City of Biddeford
Planning Board
July 21, 2021 6:00 PM City Hall
Council Chambers, & Zoom:
Jul 21, 2021 06:00 PM Eastern Time (US and Canada)
Topic: Planning Board

5. **UNFINISHED BUSINESS**
6. **NEW BUSINESS**
 - 6.A. 2021.17 - Public Hearing and Preliminary Subdivision/Site Plan Review for a proposed Contract Zone for Adams Point, LP and Southern Maine Affordable Housing at 69 Adam's Street (Tax Map 38, Lot 296) to allow for 39 units of multi-family housing in a 5-storey, 60 foot tall building (plus additional height for utility and elevator structures at a reduced parking provision 0.75 parking spaces per unit.
[2021.17 Board Report - Adams Point Prelim Plan.pdf](#)
[Site Plan Review Application & Supporting Materials_06-14-2021.pdf](#)
[Tansley Transmittal 06-14-2021.pdf](#)
[Adams Point Drawings Site Plan Review 06-14-2021.pdf](#)
[2021.10 HPC 69 Adams St COA.pdf](#)
[2021-06-25_69 Adams Street - Engineering Dept Comments.pdf](#)
[Saucier to Tansley 07-07-21.pdf](#)

Site Plan/Subdivision Preliminary Plan Review

ADAMS POINT HOUSING
69 Adams Street
Biddeford, Maine, 04005

SHEET: 4 OF 19

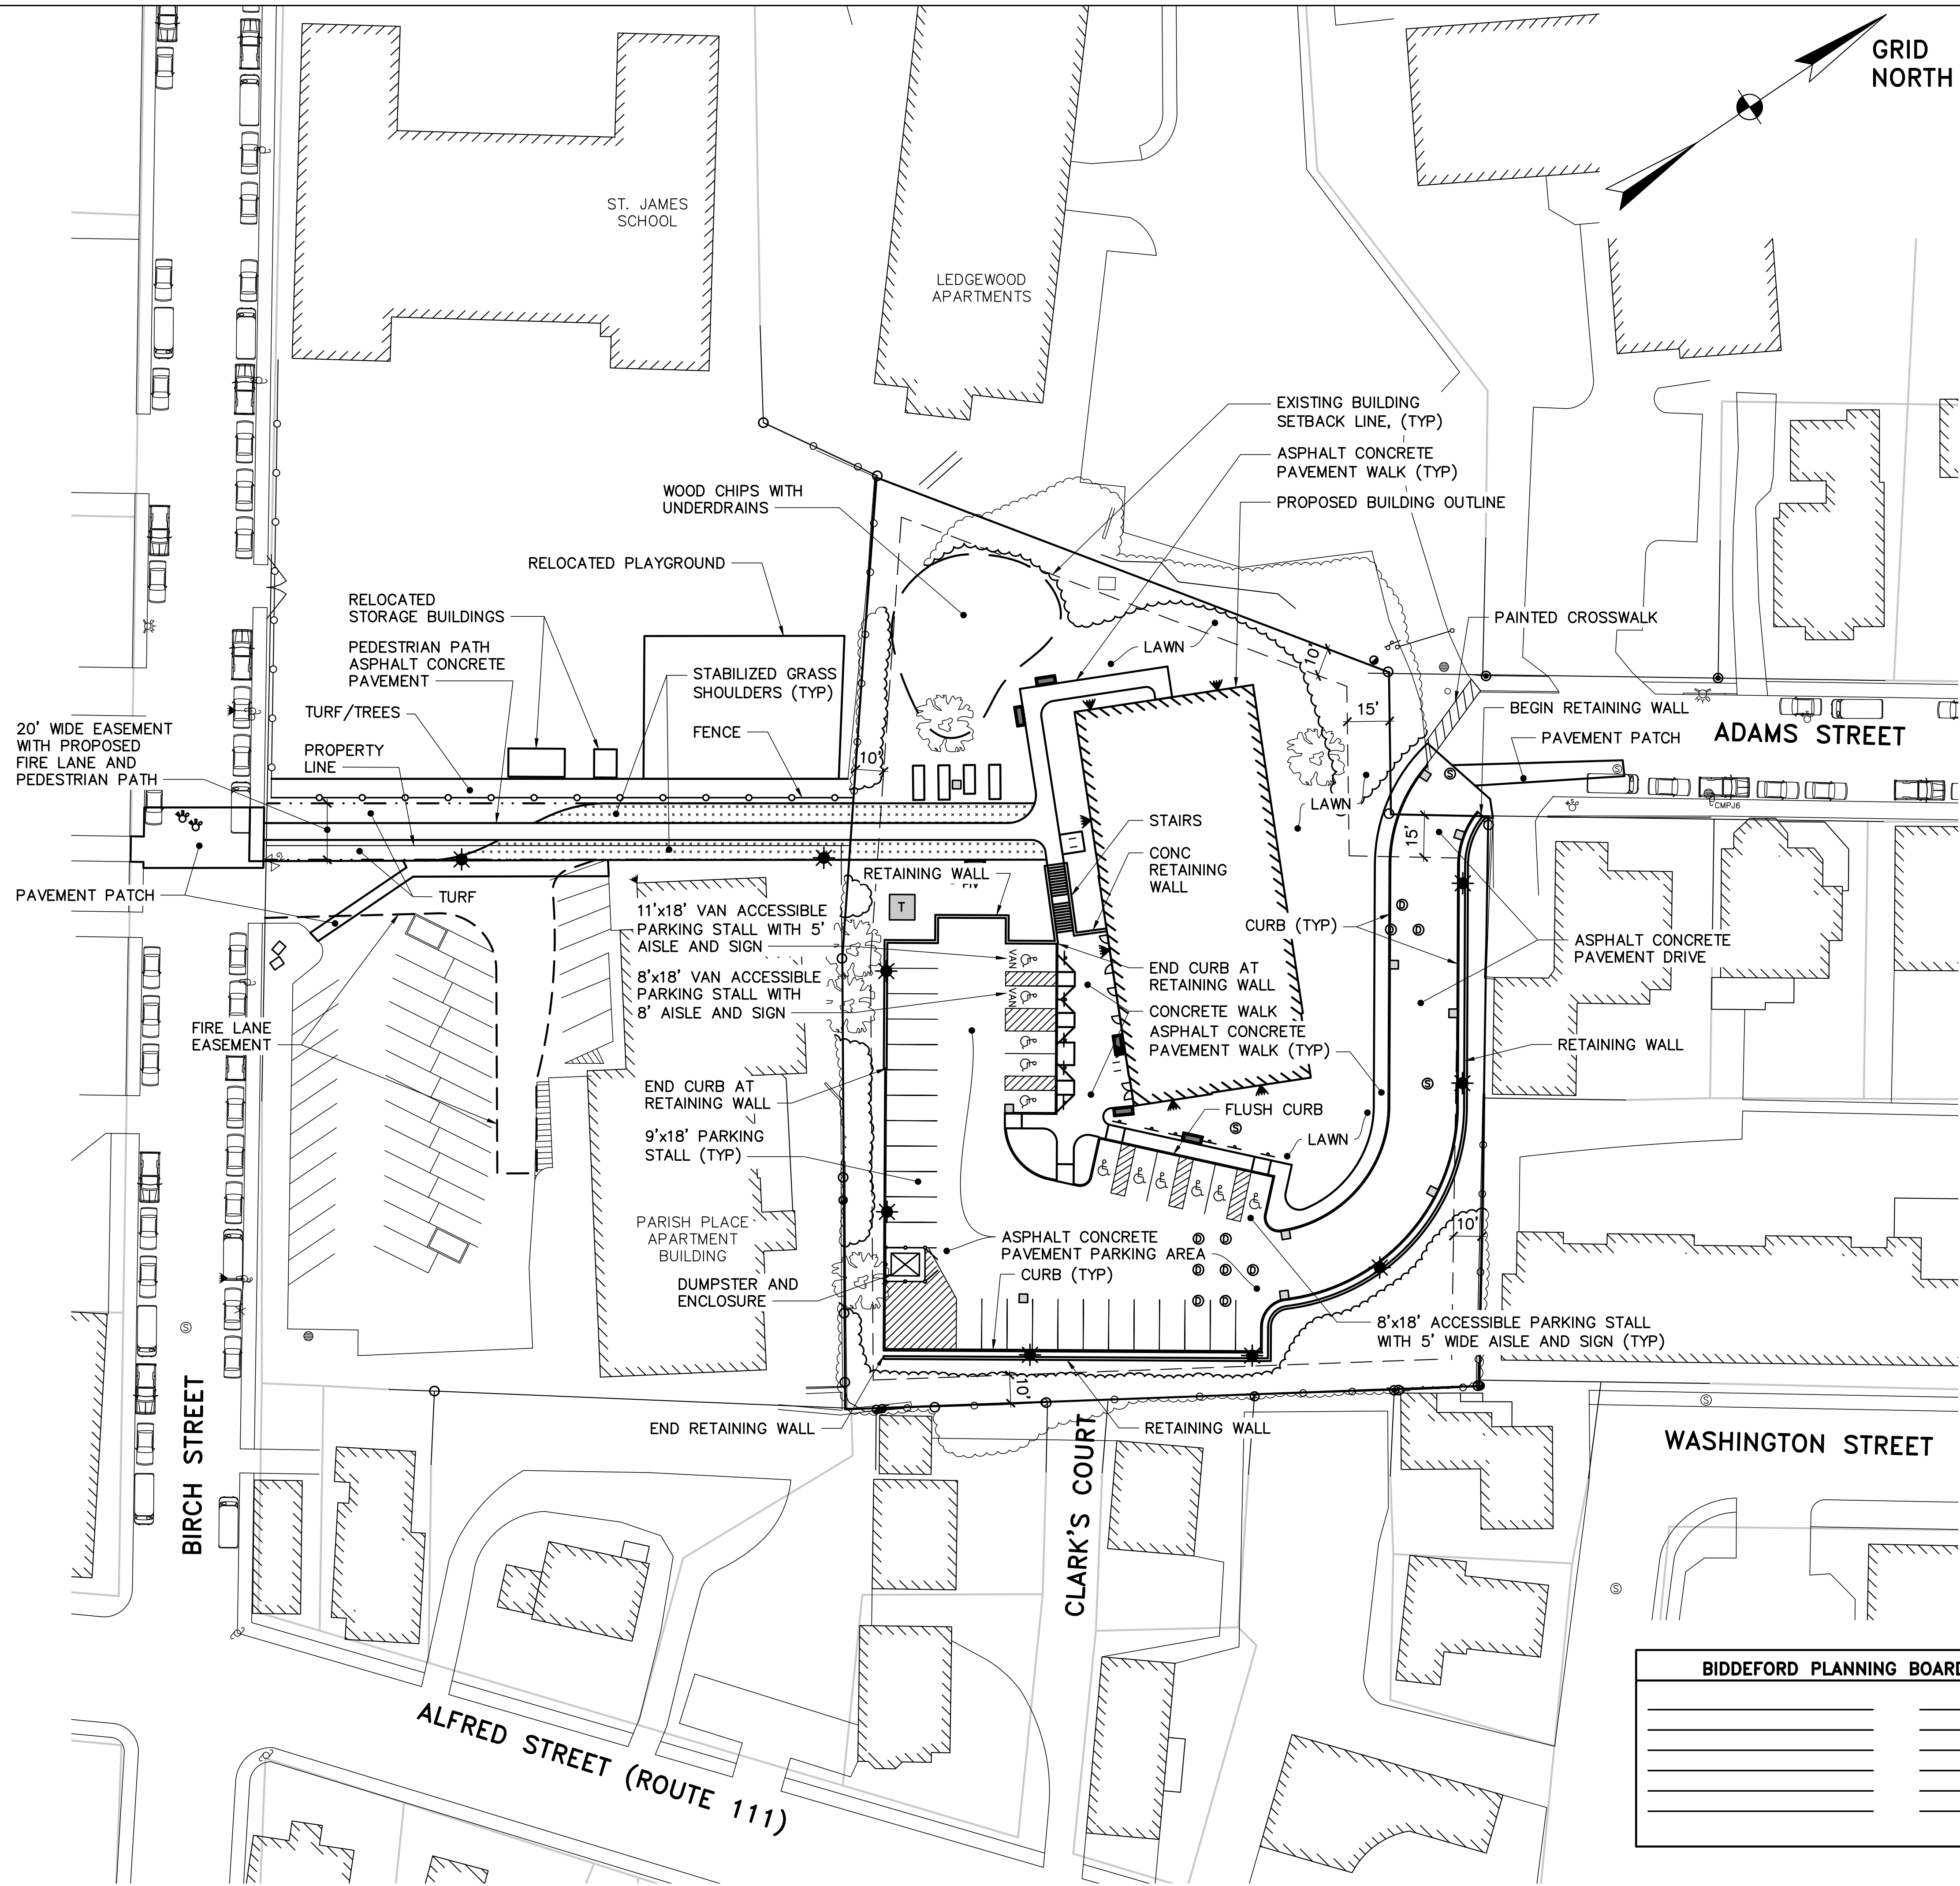
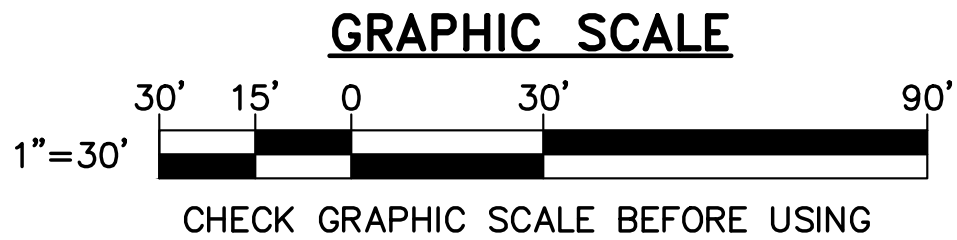
- **Sheet CS101**
 - o Curb material not identified/called-out
 - o Retaining wall material not identified/called-out
 - o Fence material not identified/called-out

- o Stops bars and signage not identified at Adams Street entrance
 - o 4" thick crushed stone surface behind sidewalk (per Detail 4/C-503) not identified on plan

1. Sheet 4 of 19 – Site Plan
 - a. The pavement repair in Adams Street should be shown with a consistent width and saw cuts and butt joints called out on the drawing.
 - b. Tactile warnings and ramps should be shown at both ends of a formal crosswalk in the public right of way.

- 4" thick crushed stone surface behind sidewalk (per Detail 4/C-503) not identified on plan. **Response: Plan will be updated to show crushed stone behind sidewalk.**

SHEET: 6 OF 19

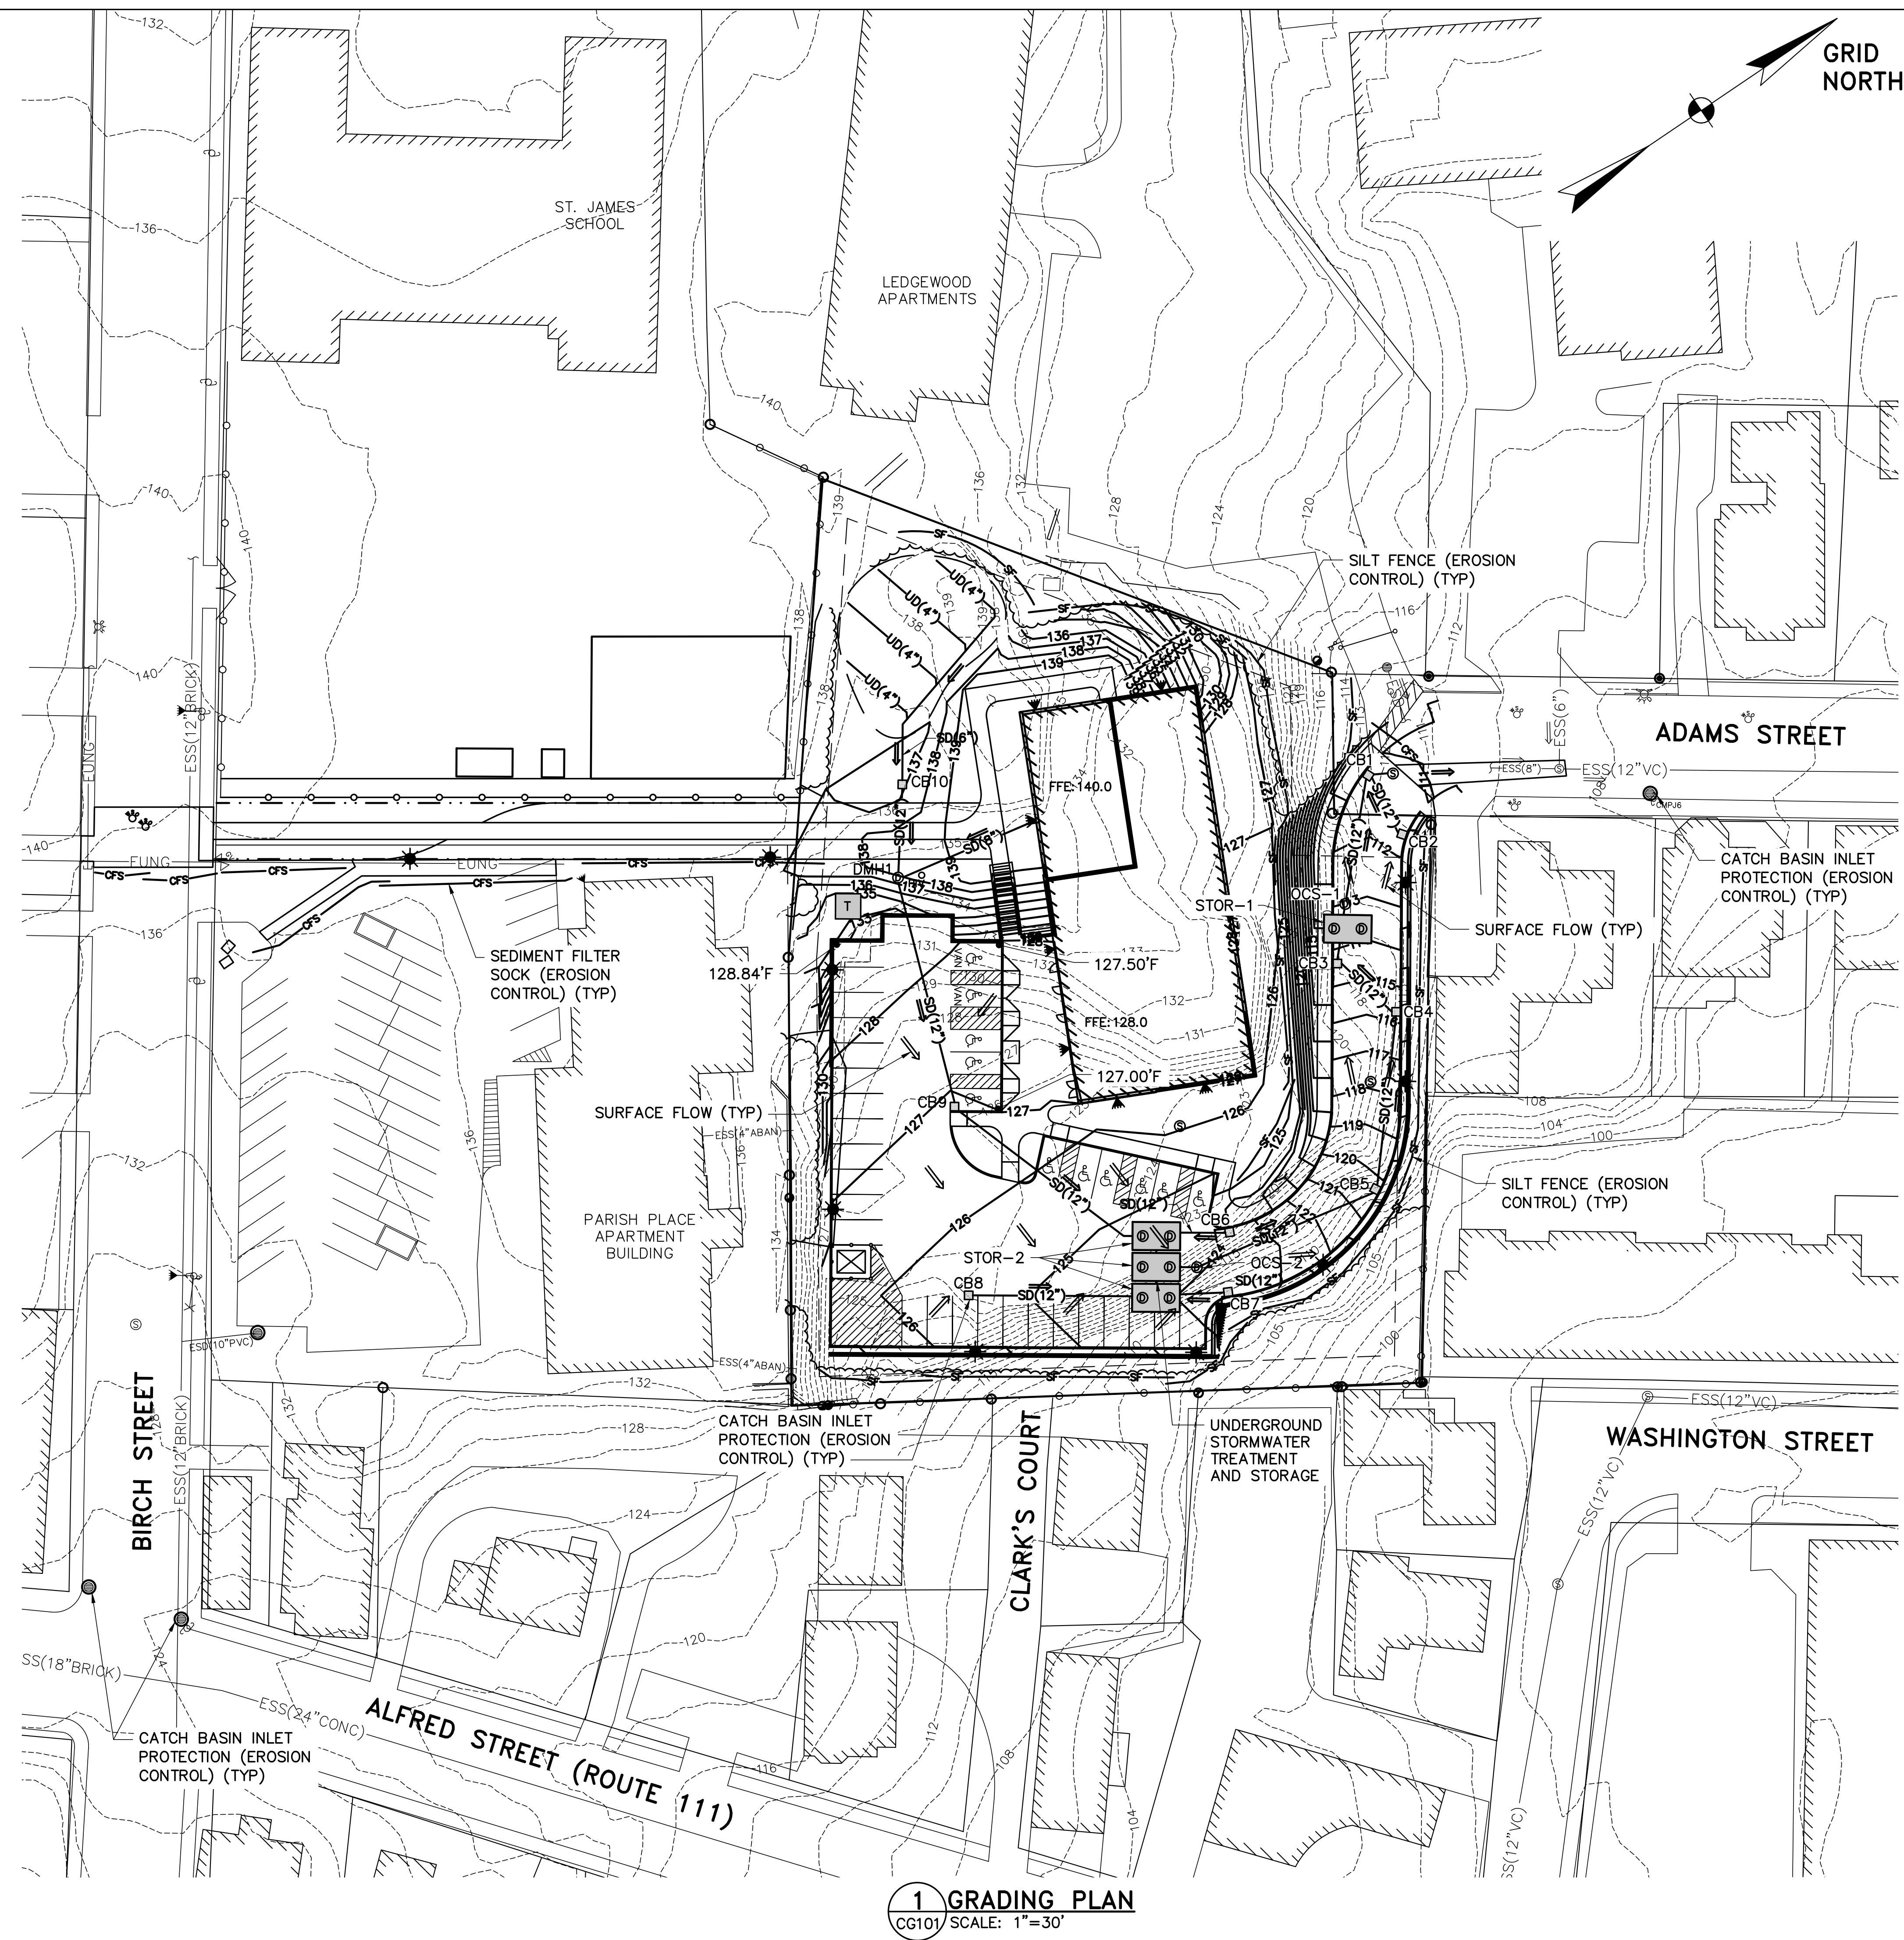
- **Sheet CU101**
 - o New storm drainage connecting to existing combined sewer; this goes against all the city's efforts for CSO abatement
 - o Callout states 'underground stormwater treatment and storage'; is water quality treatment provided, or detention only?

- o Callout states 'underground stormwater treatment and storage'; is water quality treatment provided, or detention only? **Response: This system provides storage only as treatment is not required by the DEP. The note will be corrected.**
- o Storm and sanitary profiles only provided for piping within first 200-LF of the driveway; no utility profiles provided for CB7, CB6, CB9, DMH1, SMH3, and building connections. **Response: Additional profiles will be provided.**
- o 4" thick crushed stone surface behind sidewalk (per Detail 4/C-503) not identified on plan. **Response: The plan will be updated to show crushed stone behind sidewalk.**
underdrain connection locations should be identified (i.e. retaining wall, sidewalk crushed stone). **Response: Details will be added for the items requested.**
